ADDENDUM 6

Replacement Key Biscayne Library Branch

C25-MDPLS-KB-ESP

5-SEP-2025

Clarification on finishes for the interior and interior signages:

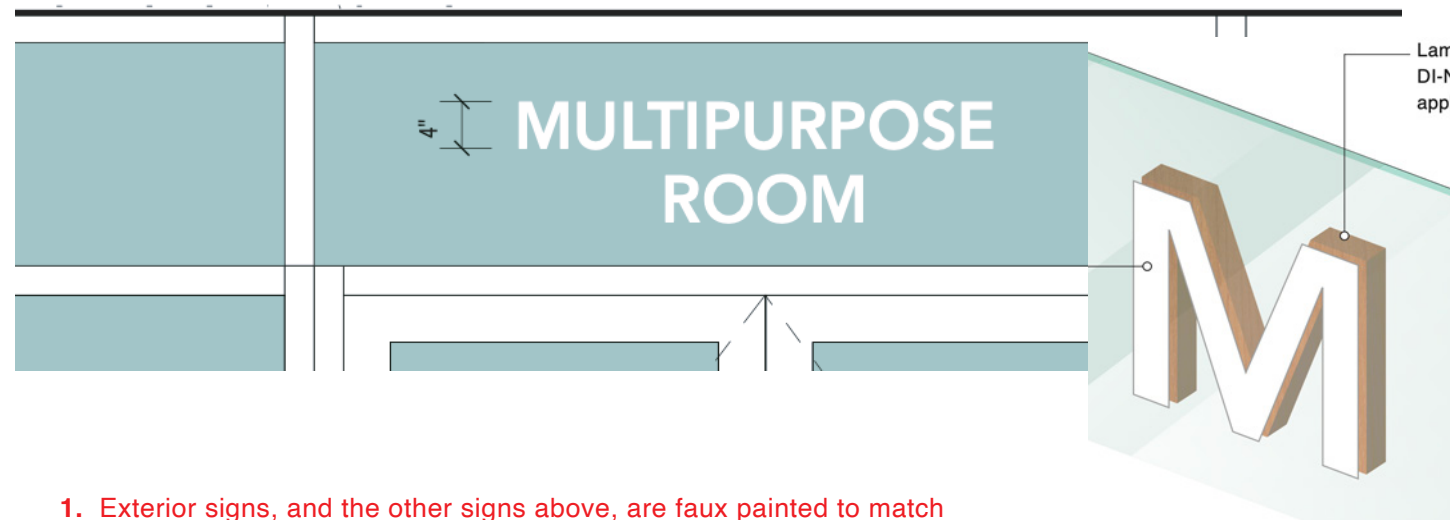
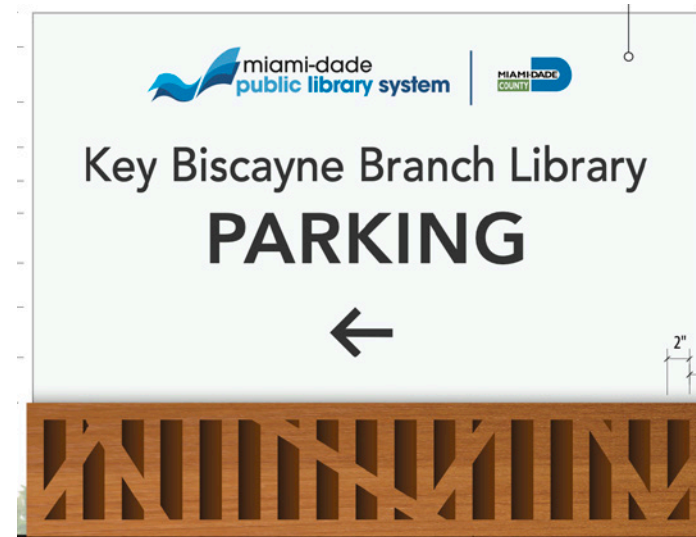
See the enclosed attachment in this addendum with some notes in regard to the “wood” finish for the exterior and interior signage. Please be advised that overall, the notes would stay the same, some are faux painted and some required laminate. Final color selection by MDPLS.

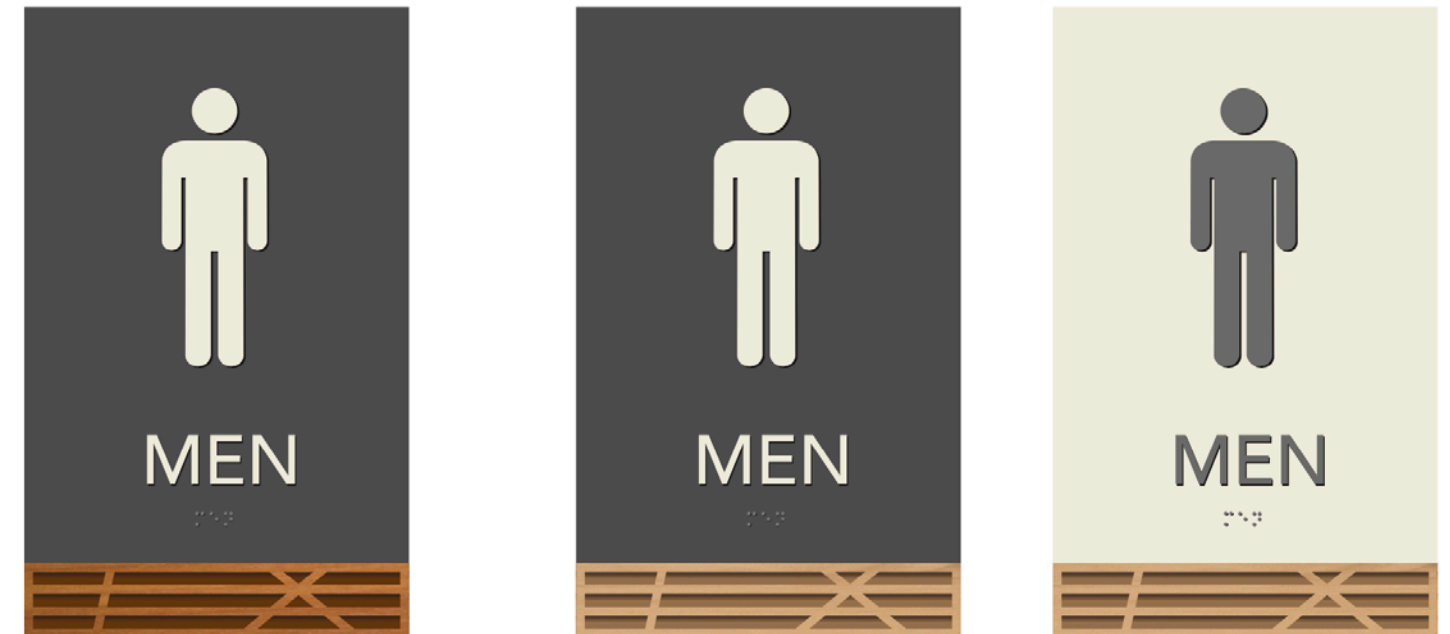
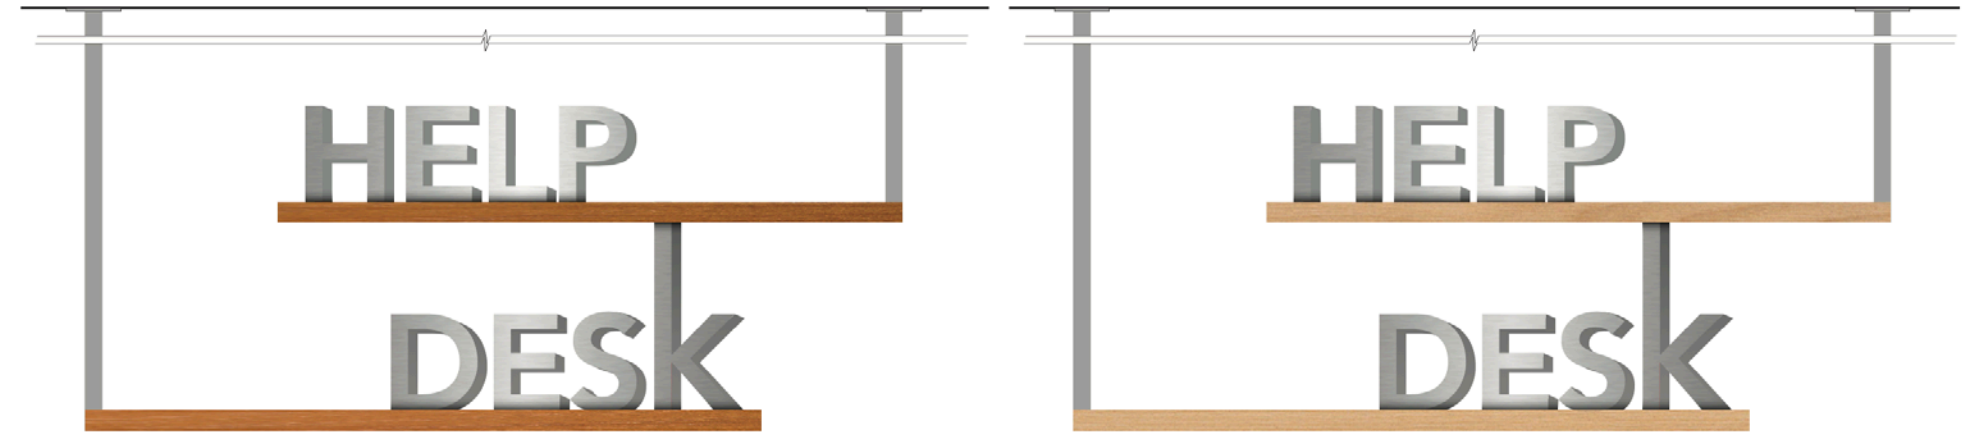
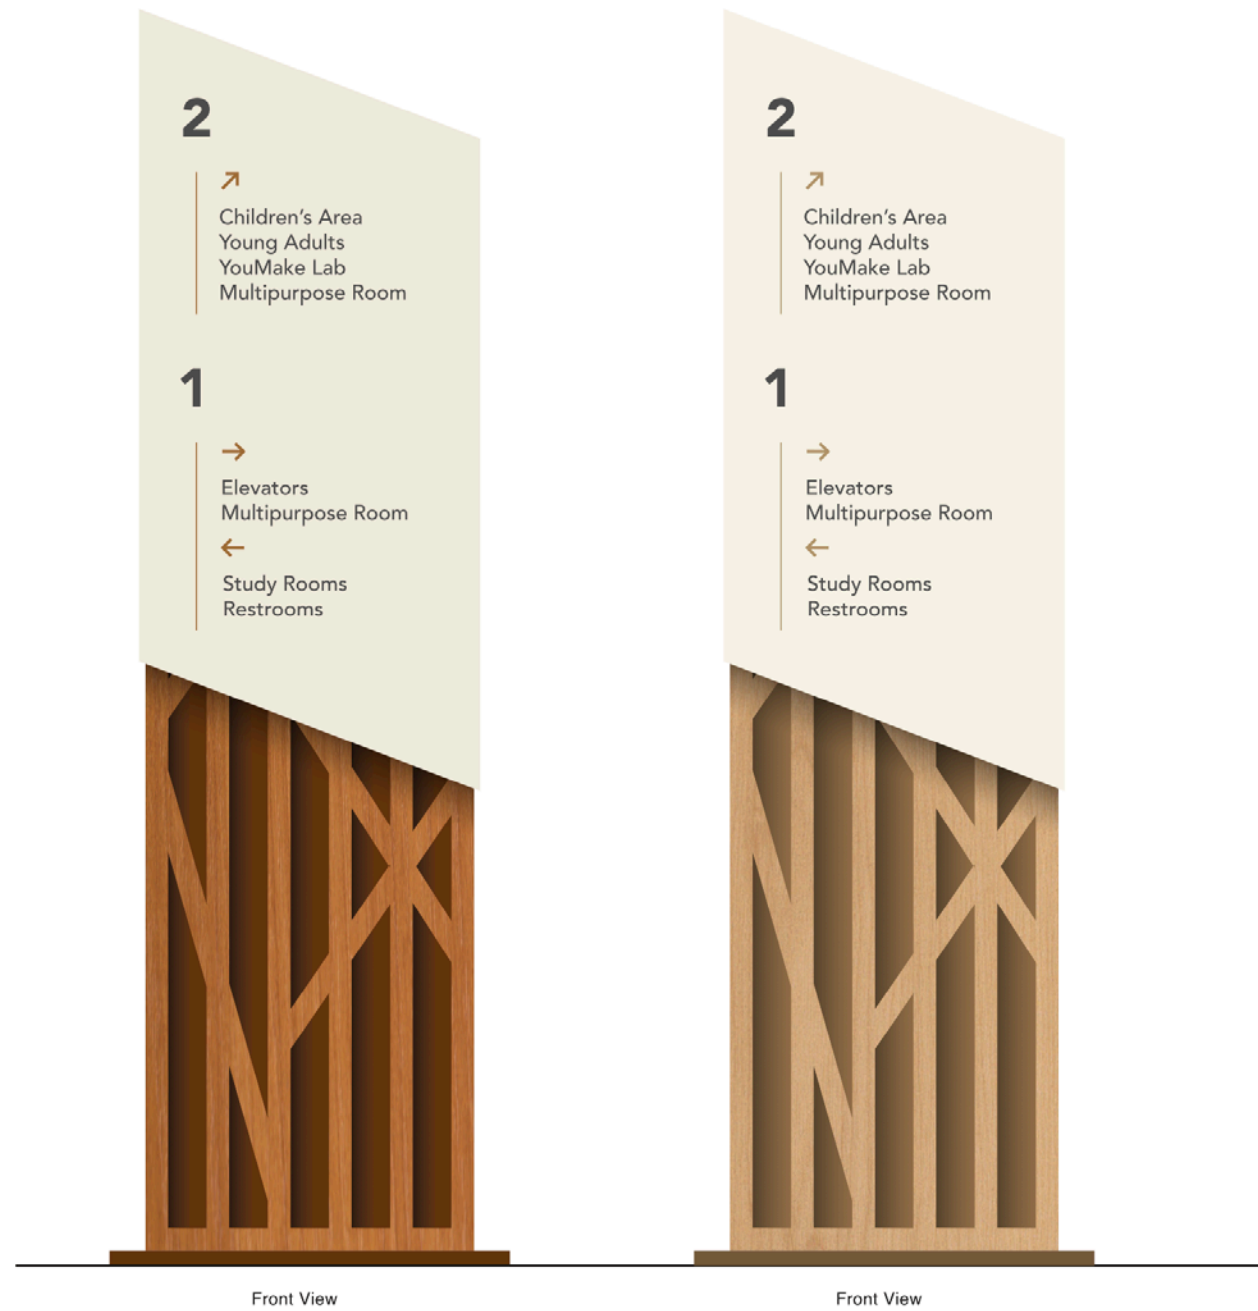
1. Exterior signs, and the other signs above, are faux painted to match the rest of the signs. Stain color tbd.

2. For Directory signs, use teak/mahogany wood stained to match the rest of the signs. Stain color tbd. Matte finish.

3. Wood grain to match ~~3M™ DI-NOG™ Architectural~~ ~~Finishes WC-866~~. Self-adhesive Laminates to be applied on first surface or painted to match.

3. ADA plaques will use a Wilsonart standard laminate Tuscan Walnut 7921-38 Fine velvet finish.

or

Lamitech Fresno 0470, depending on final furniture selection (by client)

Laminates 3M™ DI-NOC™ Architectural
Finishes **WG-866**.

NOTE: Current option for
Interior signs. Pending final
approval
